ND-2012-0010  
February 10, 2012

Subject: **PSEG Early Site Permit Application**  
**Docket No. 52-043**  
**Response to Request for Additional Information, RAI No. 44, Surface Faulting**

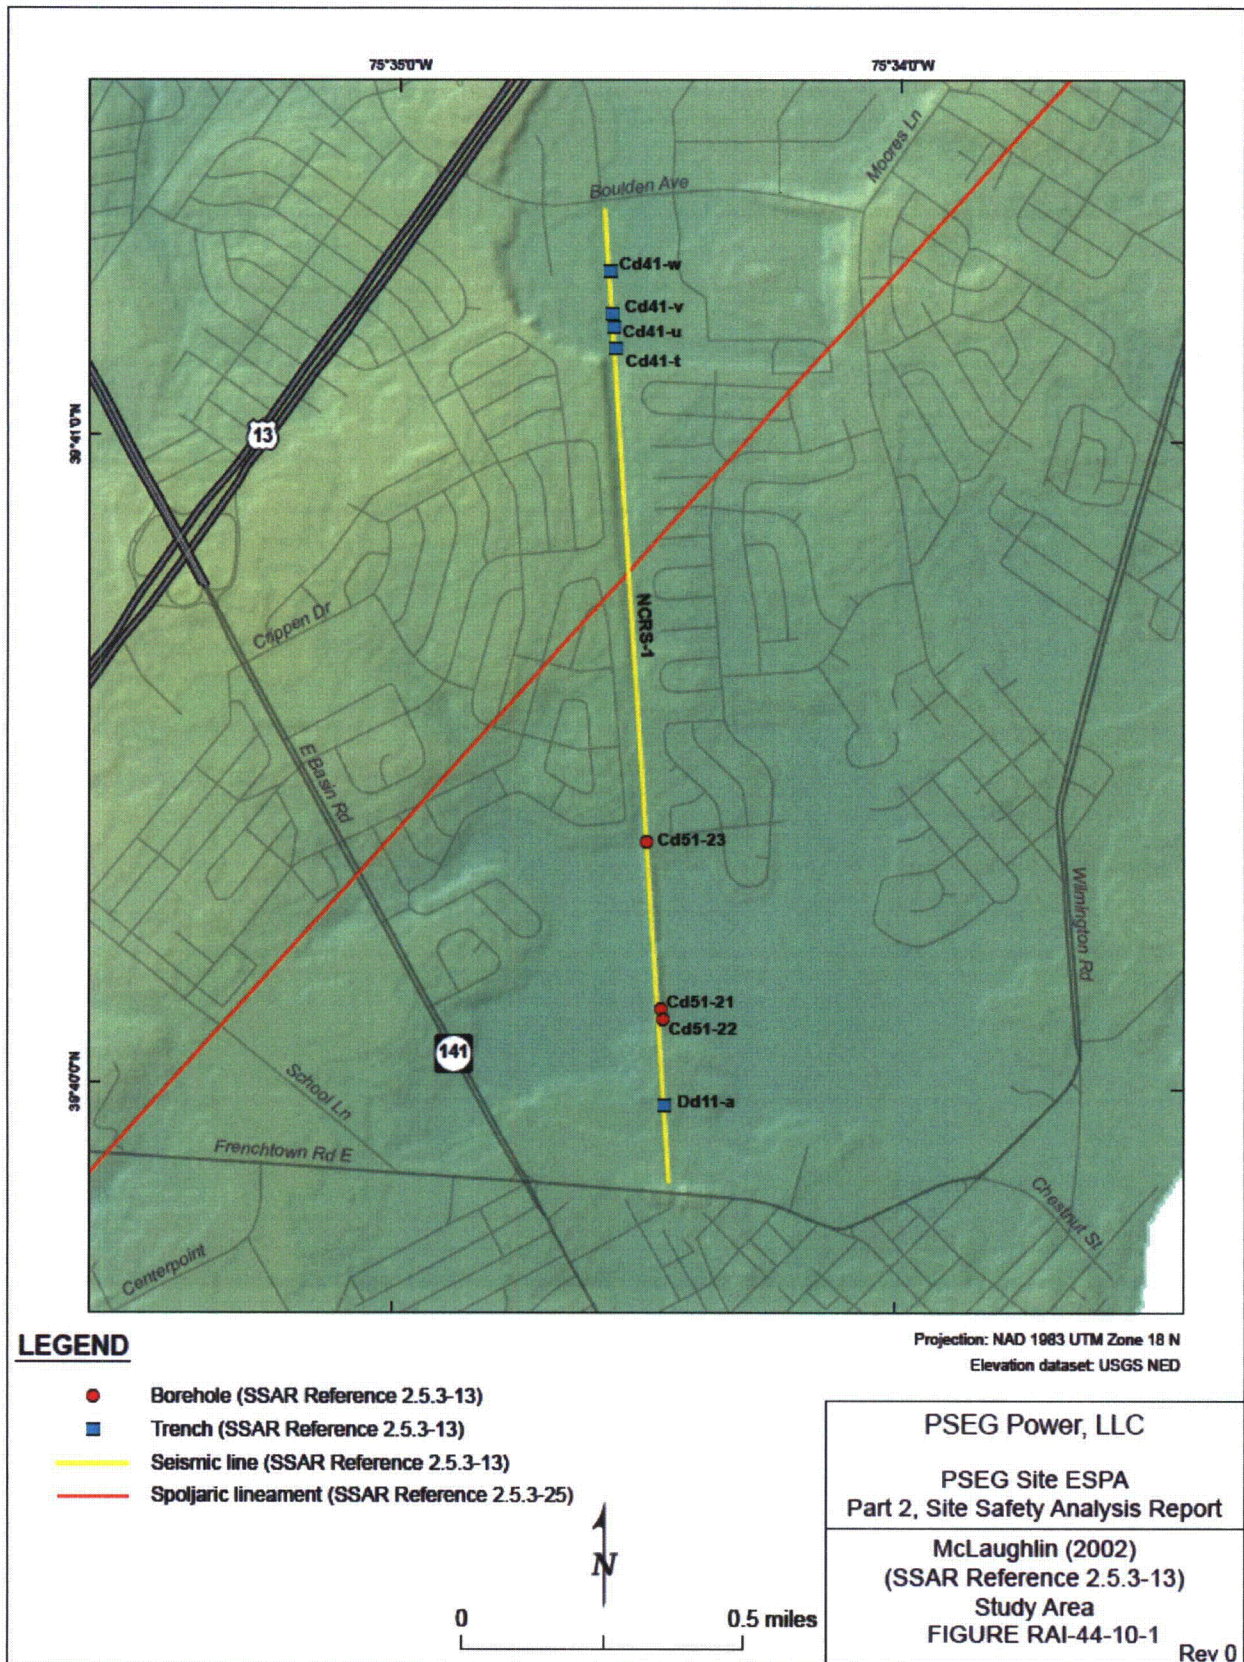
*SSAR Subsection 2.5.3.2.2, "Faults Buried by Coastal Plain Sediments," discusses the lineaments and basement faults postulated by Spoljaric (1972, 1973, 1974, 1979), broadly known as the New Castle County faults, two of which extend into the site area as lineaments (based on Landsat data). The SSAR description distinguishes between the postulated basement faults and the lineaments, and states that the basement faults have been demonstrated to be pre-Cretaceous in age, thus posing no surface faulting hazard at the site. However, SSAR Subsection 2.5.3.2.2 does not summarize the data that demonstrate the validity of a pre-Cretaceous age. The SSAR further indicates that the interpretation of a young age for the lineaments is unsupported for the following reasons: (a) Borings have not revealed offsets in near-surface units that cross the projection of the lineaments; (b) earlier studies show that basement faults do not extend into Cretaceous or Tertiary units; (c) trenching of one lineament north of the PSEG site revealed unfaulted Tertiary and Quaternary units; and (d) Spoljaric (1974) noted that surface faulting was not evident along the lineaments. However, the SSAR does not indicate which lineament was trenched to conclude that Quaternary units were not offset along the lineament.*

*In order for the staff to adequately evaluate the potential for faulting within the PSEG site vicinity and at the PSEG site, and in compliance with 10 CFR 100.23 and in conformance to NUREG 0800, Section 2.5.3, "Surface Faulting," please clarify what data were used to demonstrate the validity of a pre-Cretaceous age for the basement faults of Spoljaric. Please also clarify which lineament was trenched and provide additional details of the trench investigation, as this action provides support for concluding that the lineaments do not represent Quaternary faults.*

The Delaware Geological Survey conducted a detailed study in New Castle County to determine if there was any evidence for near-surface deformation related to lineaments or basement faults identified by Spoljaric (SSAR Reference 2.5.3-25) and to assess earthquake hazards in northern Delaware (SSAR Reference 2.5.3-13) (note this is also SSAR Reference 2.5.1-128, and is depicted on SSAR Figure 2.5.1-19). The study included a seismic reflection line (NCRS-1) designed to image the top 1500 feet of the subsurface, three deep borings (350-550 feet in depth to reach basement) that were designed to intersect postulated basement faults, and five shallow (5-8 feet in depth) trenches to examine surficial strata (Figure RAI-44-10-1). The data and conclusions presented in SSAR Reference 2.5.3-13 did not provide any evidence of shallow tectonic deformation or faulting along this transect.

The borings and the trenches were located within a mile of the proposed trace of a nearby northeast-trending Spoljaric lineament, and along strike of several basement

faults identified by Spoljaric to the southwest (SSAR Figure 2.5.1-19; Figure RAI-44-10-1; SSAR Reference 2.5.3-26).

The information from the five trenches, as described in SSAR Reference 2.5.3-13, is summarized below.

- Trench Cd41-t identified five lithologic units- mostly sands- interpreted as part of the Quaternary Columbia formation. The contacts between the units were horizontal.
- Trench Cd41-u described six lithologic units including upper portions of the Cretaceous Potomac Formation in addition to the Quaternary Columbia Formation. Contacts between the units dip gently (<10 degrees) to the north.
- Trench Cd41-v contained four lithologic units which dip northward, also composed of Potomac Formation overlain by Columbia Formation.
- Trench Cd41-w exposed clays tentatively assigned to the Columbia Formation that were cut by an erosional surface.
- Trench Dd11-a, located to the south of the other trenches, exposed flat-lying clays overlain by sands, interpreted as Potomac formation overlain by the Quaternary Lynch Heights Formation.

These trenches were located to test hypothesized faulting in early interpretations of the seismic reflection data. No evidence of faulting was encountered in any of the five trenches in the Potomac formation or the overlying Quaternary deposits (SSAR Reference 2.5.3-13). These trenches, along with the boring data, and reinterpretations of the seismic data indicate an unfaulted shallow section along the NCRS-1.

**CD-ROM Containing Revised SSAR Figure 2.5.3-1**

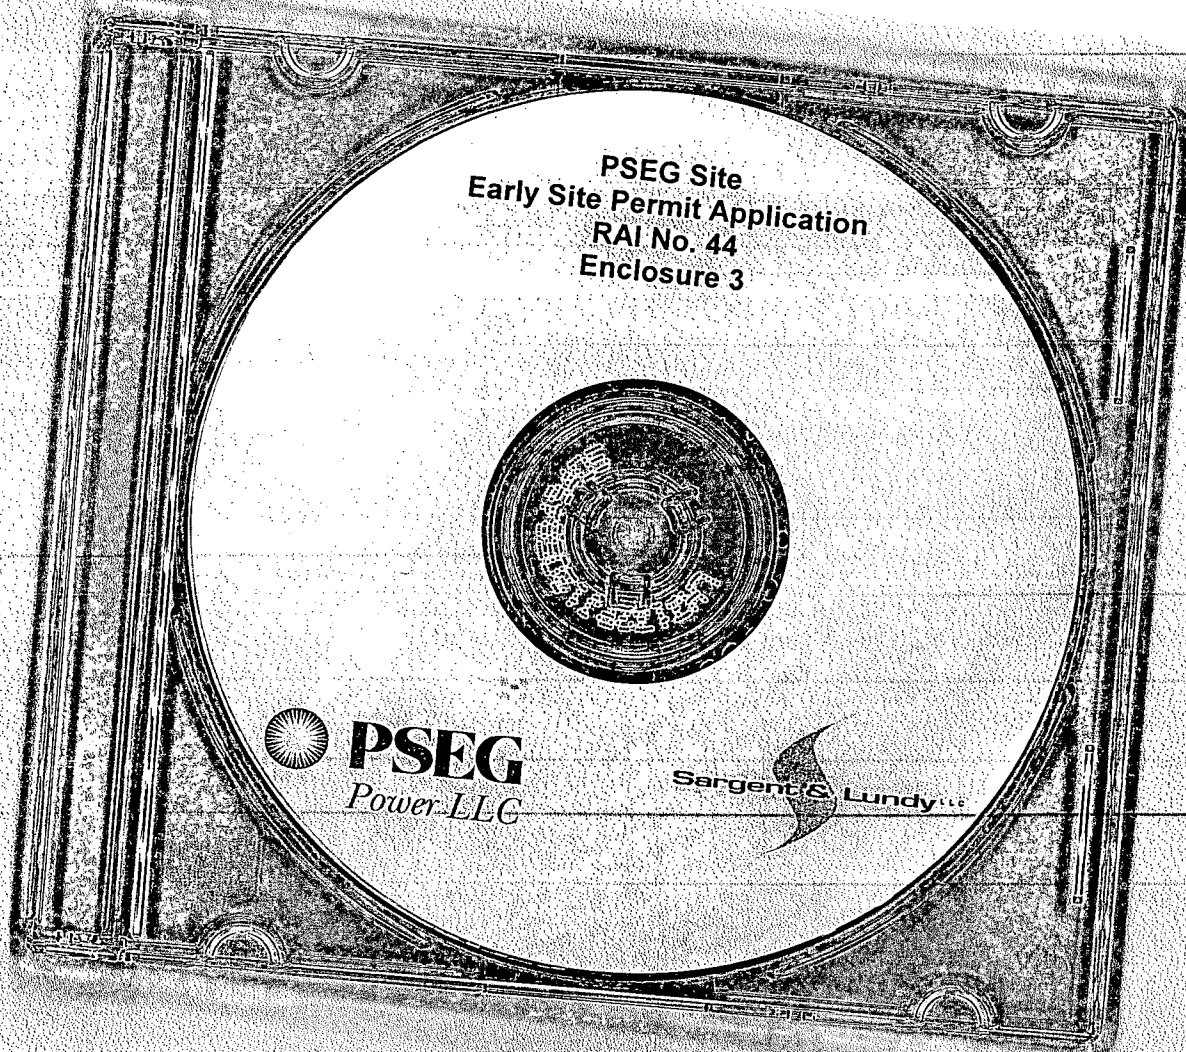
*SSAR Figure 2.5.3-1 includes a north-northwest yellow line that is not defined in the figure legend and it is not clear what this line represents on the map showing site vicinity geology and seismology. The SSAR Figure 2.5.3-1 map legend identifies only Cretaceous and Quaternary coastal plain units, which is inconsistent with SSAR Figure 2.5.1-12a that shows tertiary units in the eastern portion of the site vicinity.*

*In order for the staff to adequately evaluate the potential for faulting within the PSEG site vicinity and at the PSEG site, and in compliance with 10 CFR 100.23 and in conformance to NUREG 0800, Section 2.5.3, "Surface Faulting," please update the legend in SSAR Figure 2.5.3-1 to be consistent with SSAR Figure 2.5.1-12a and please identify the north-northwest yellow line included in the map. Also, please explain the significance of Quaternary units in contact with Cretaceous units along the fall line west of the site.*

The legend of SSAR Figure 2.5.3-1 should read Cretaceous-Quaternary units. The missing hyphen will be inserted on the revised figure as shown in Enclosure 3. The north-northwest trending yellow line is one of the lineaments identified by Spoljaric (SSAR Reference 2.5.3-25). The line color and style of the line depicting this lineament is also corrected in the updated version of SSAR Figure 2.5.3-1.

SSAR Figure 2.5.3-1 will be updated as specified in Enclosure 3 of this document.
